Item Name: AS350/AS355 Quick Release Heli-Utility-Basket™, Short, Heavy Duty Lid

DART SERVICE INSTRUCTION

TO AMEND INSTALLATION INSTRUCTIONS D350-607-3 Rev.D, **SHOP COPY**
INSTALLATION INSTRUCTIONS D350-607-4 Rev. C AND **RETURN TO**
INSTRUCTIONS FOR CONTINUED AIRWORTHINESS ICA-D350-607 REV.16 **ENGINEERING**

A	NEW ISSUE	AJS	14.05.16
REV.	DESCRIPTION	BY	DATE
DESIGN	AJS		
DRAWN	AJS		
CHECKED			
MFG. APPR.	N/A		
APPROVED			
DE APPR.			
DATE	14.05.16		
		TITLE	SCALE
		LUG REPLACEMENT	NTS

FIGURE 1: INSTALLATION OF D4775-041 FWD STRUT

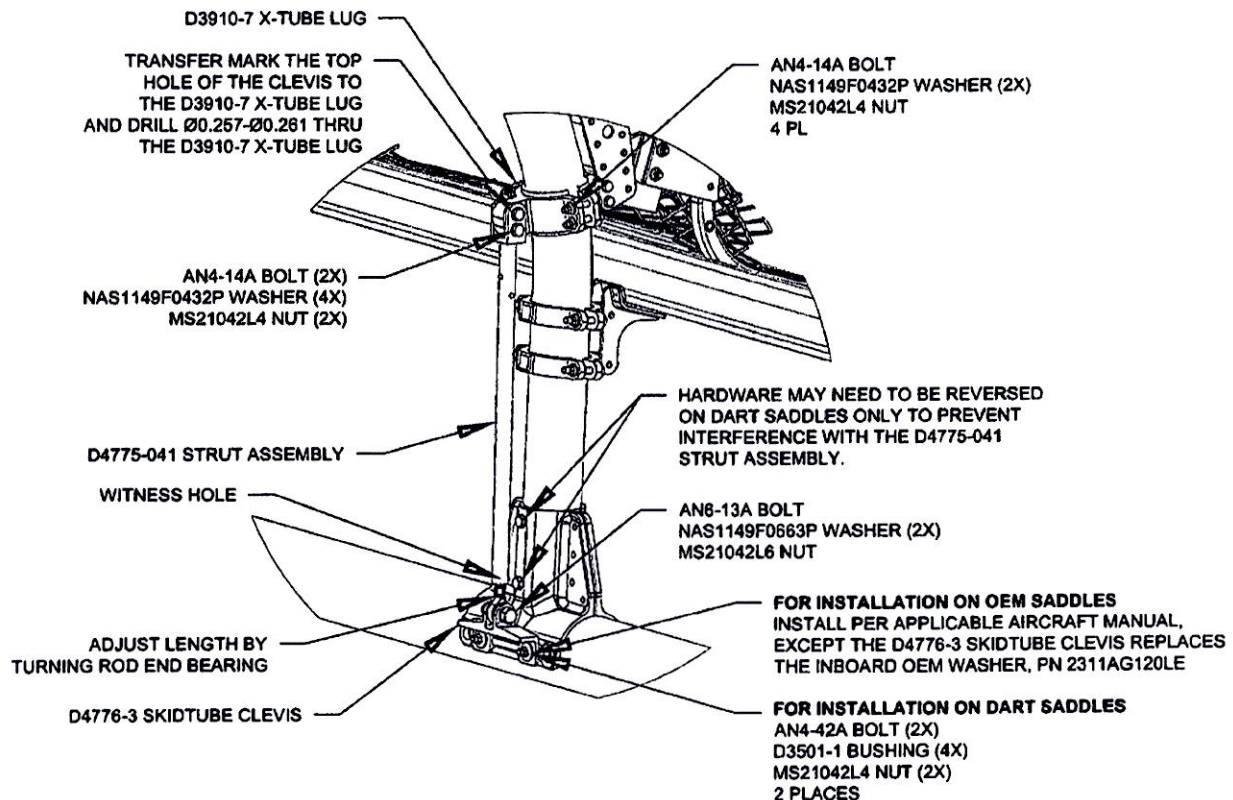
- 3.1 Substitute the Forward Lower D3910-5 X-Tube Lug with the D3910-7 X-Tube Lug as shown in Figure 1.
- 3.2 Install the forward D4775-041 Strut Assembly. Transfer mark from the upper hole on the clevis of the D4775-041 Strut Assembly to the D3910-7 X-tube Lug and drill thru the lug $\varnothing 0.257$ - $\varnothing 0.261$ as shown in Figure 1. Touch up chemical conversion coating per MIL-DTL-5541. Check the witness holes located at the bottom end of the D4775-041 Strut Assemblies to ensure that the thread from the rod end extends past the witness hole.
Torque MS21042L4/-4 nuts to 50-70 in-lbs (5.7-7.9 N-m). Torque MS21042L6/-6 nuts to 160-190 in-lbs (18.1-21.5 N-m).
- 3.3 Complete the installation in accordance with Installation Instructions D350-607-3 Rev. D or D350-607-4 Rev. C.
